IDAHO DEPARTMENT OF
WATER RESOURCES

RE: Bray Lake Water Right & Dam Safety Report Storage Volume Discrepancy

TO: Corey Skinner
FROM: Tyler Wallace
PROJECT: Bray Lake Dam
IDWR FILE: 37-2778

Memorandum regarding the re-evaluation of the storage capacity for Bray Lake.

Figure 1. Aerial view of Bray Lake Dam with appurtenant features. The approximate surface area for the reservoir at or near full capacity was calculated using ArcMap and is shown in the above figure.

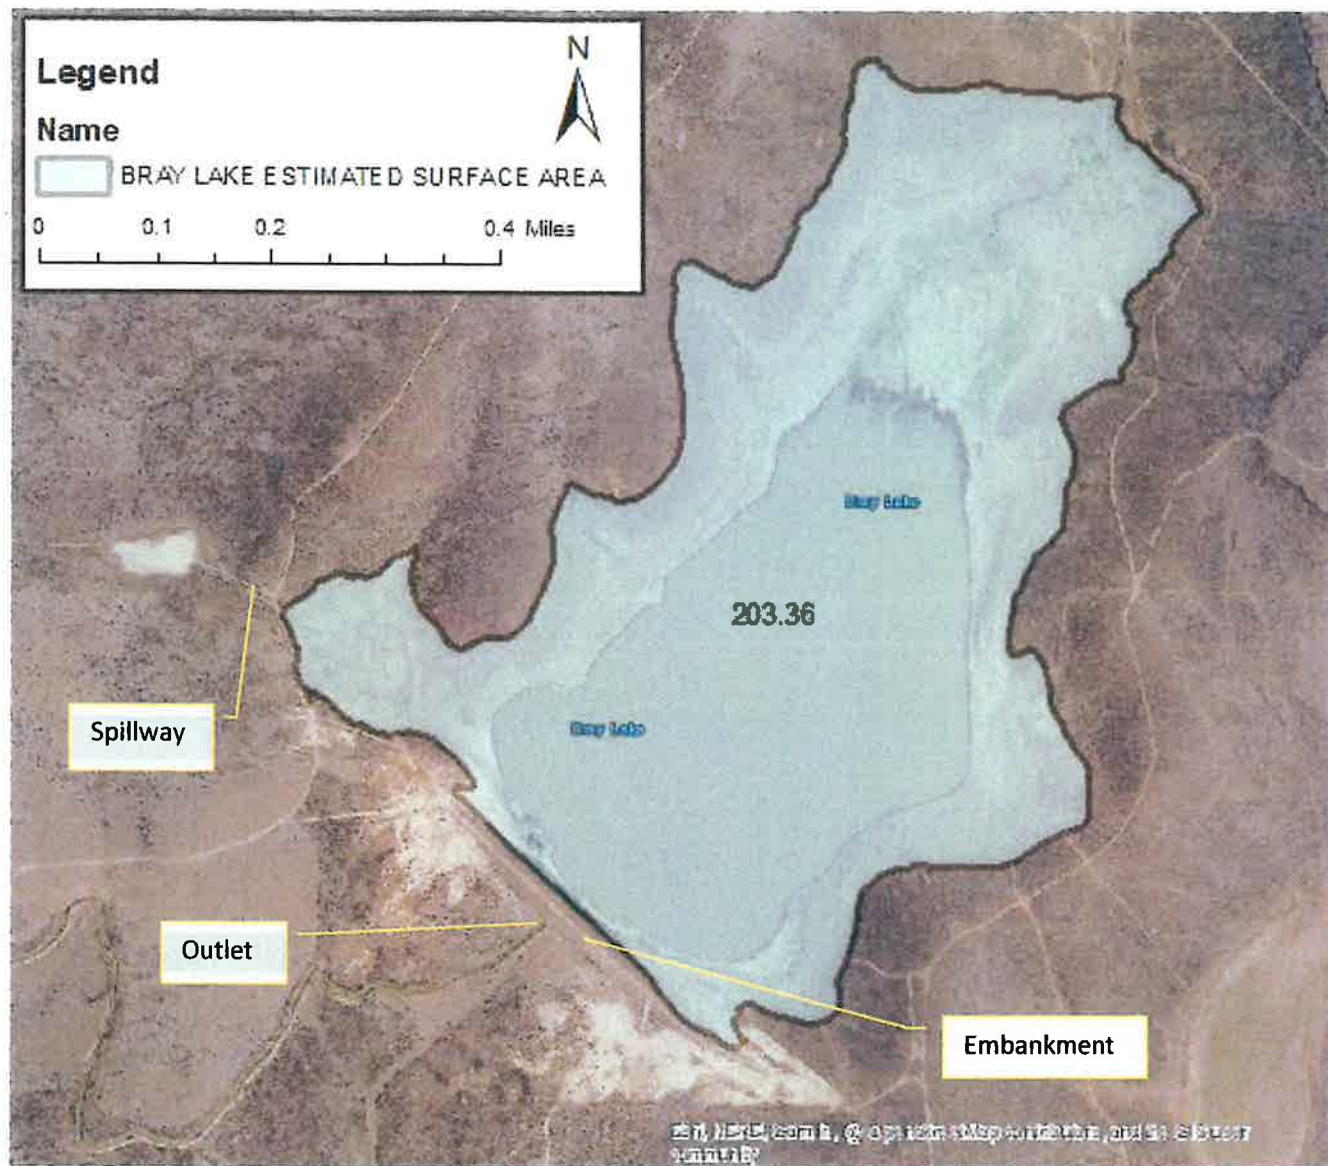
I was instructed to perform my own evaluation of the storage capacity for comparative purposes. Using aerial imagery, I calculated the surface area to be approximately 203.4 acres (see figure 1). Based on an IDWR survey of Bray Lake dam, which was conducted on 9/21/1992 and resurveyed on 9/6/2000, the hydraulic height (as measured from the outlet invert to the crest of the spillway) was reported to be 33.0 feet. The reservoir storage capacity can then be calculated using the standard storage capacity formula as follows:

$$\text{Reservoir Storage Capacity} = \text{Hydraulic Height} * \text{Reservoir Surface Area} * 0.4 \text{ (correction factor)}$$
$$\text{Reservoir Storage Capacity} = 33 \text{ feet} * 203.4 \text{ acres} * 0.4 = \mathbf{2685 \text{ acre feet}}$$

The reservoir storage capacity value I calculated in my analysis is nearly the same as what was calculated in the previous 2018 memo. Therefore, I recommend that the reservoir storage capacity, as recorded in the dam safety database, remains at 2,693 acre-feet as recommended in the 2018 memo.
